Amendment # 2

Approved Building Consent Document

TODD RESIDENCES - 53 EDWARD AVENUE - CHRISTCHURCH

SITE PLAN

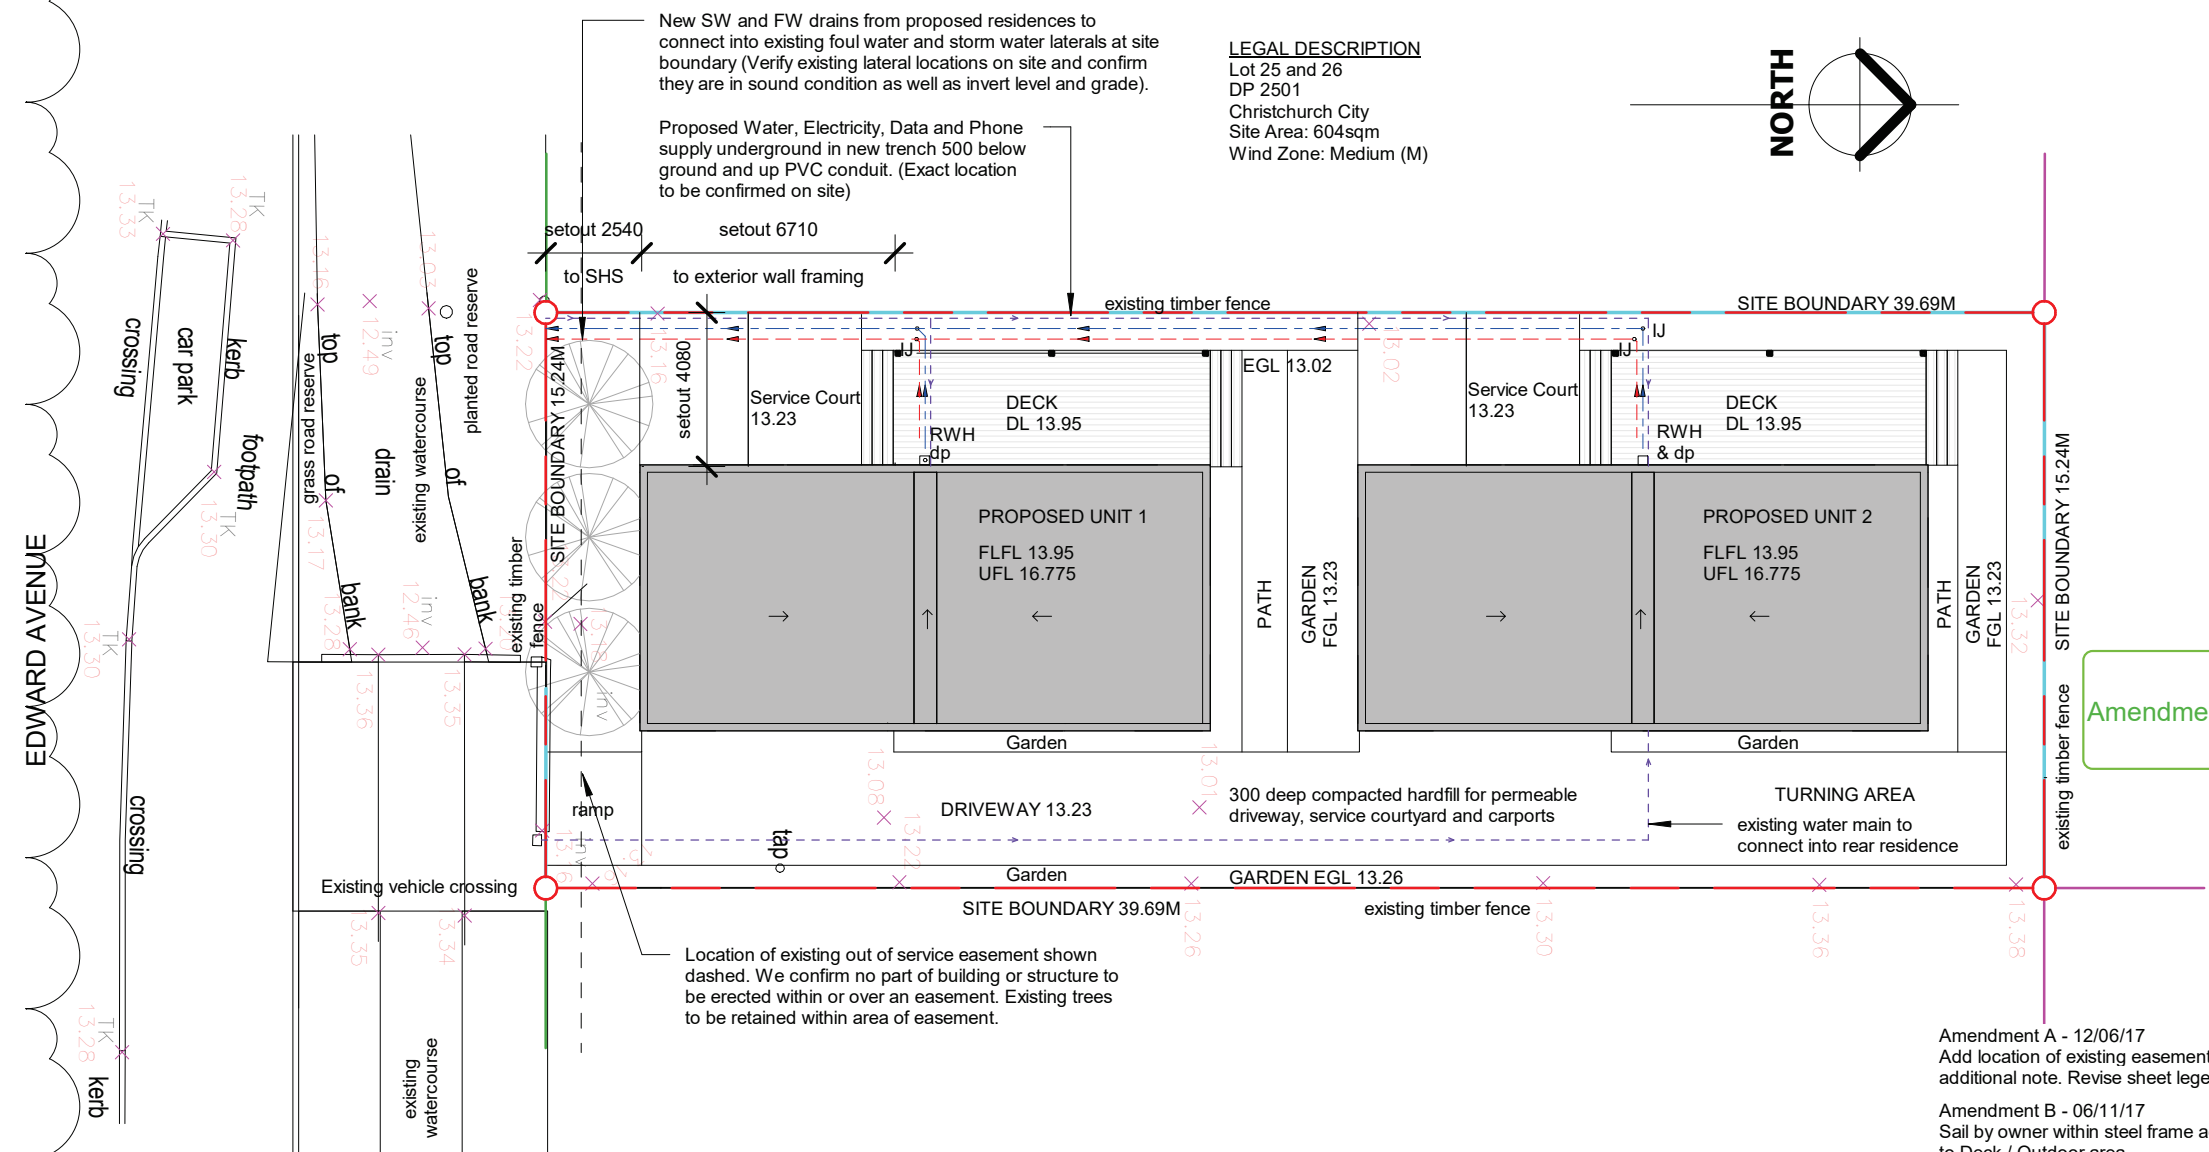
Amendment A - 12/06/17
Add location of existing easement and additional note. Revise sheet legend.

Amendment B - 06/11/17
Sail by owner within steel frame added to Deck / Outdoor area.
Gravel path added to Garden.

Amendment C - 22/11/17
Existing water main updated to connect into rear residence.

FOUNDATION PLAN

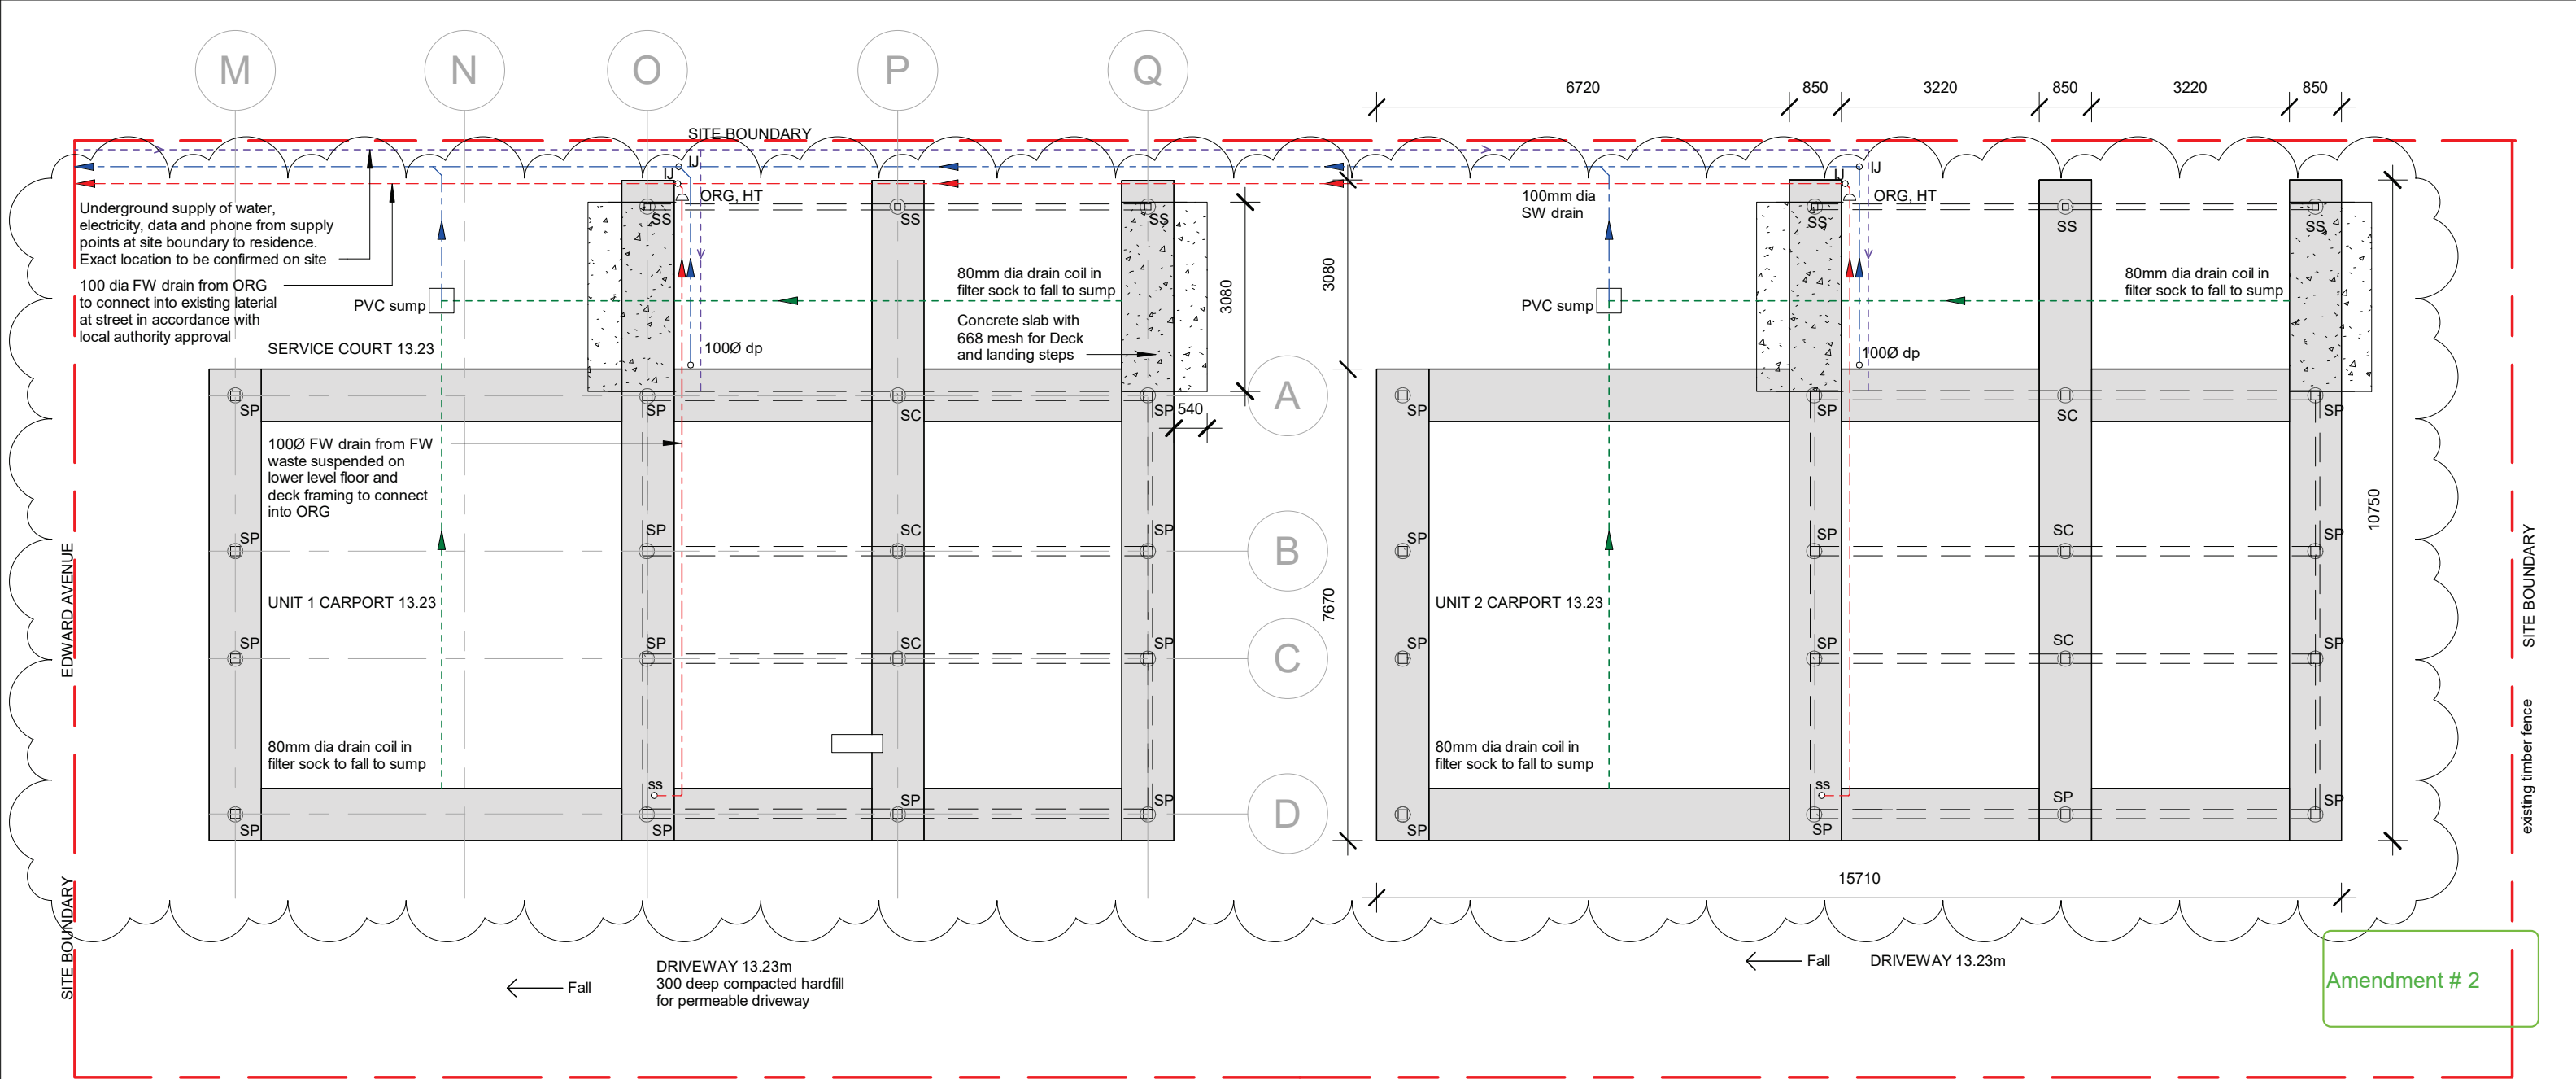
Amendment A - 6/11/17
Foundation pad for entrance porch removed

Amendment B - 12/06/18
Drain coil and sump added.
Plumbing and drainage key updated.

LOWER LEVEL PLAN (2 residential unit setout)

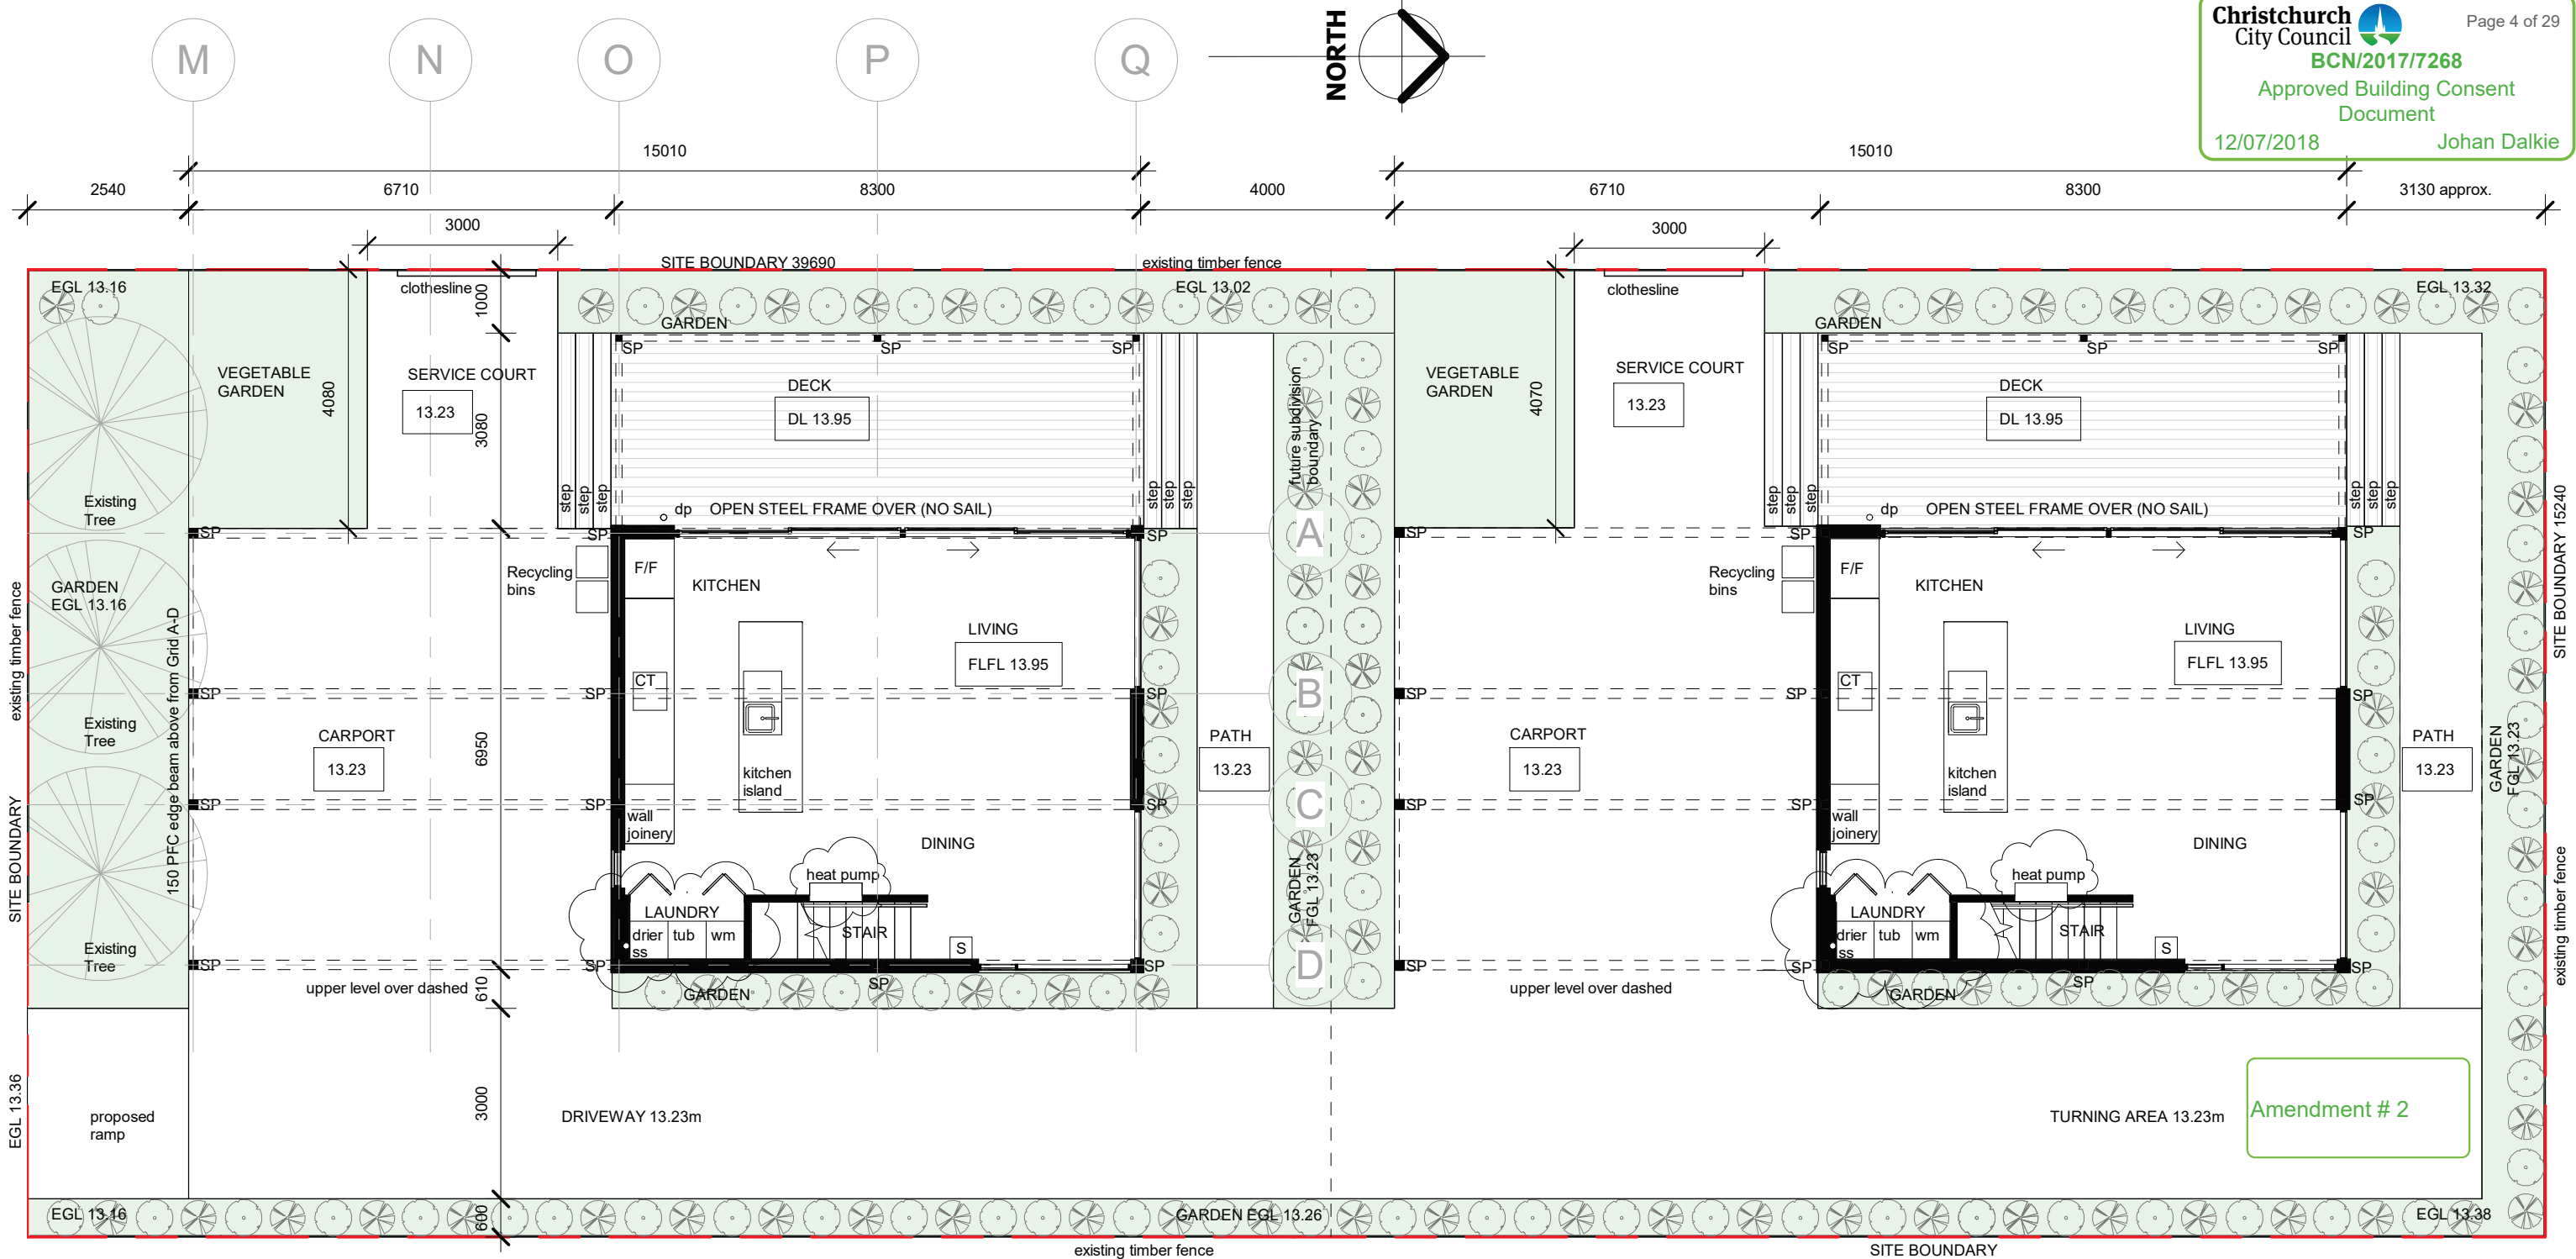
Amendment A - 6/11/17
Entrance porch and steps removed.
Front entry door changed to glazed full height window.
Sail by owner within steel frame added to Deck / Outdoor area.
Heatpump changed to a ceiling cassette unit.
Garden path added to deck.

Amendment B - 27/03/18
Front entry glazed full height window reduced to 600 wide.
Sliding stacker doors changed to 2 sliders over 2 fixed panels.
Kitchen location adjusted.
Amendment C - 30/04/18
Laundry wall shortened to provide access to under the stair.

Amendment D - 30/05/18
Location of Kitchen Island and Heatpump adjusted.

Amendment E - 17/06/18
Laundry sliding door replaced with bi-fold doors. Heat pump location moved to stair wall.
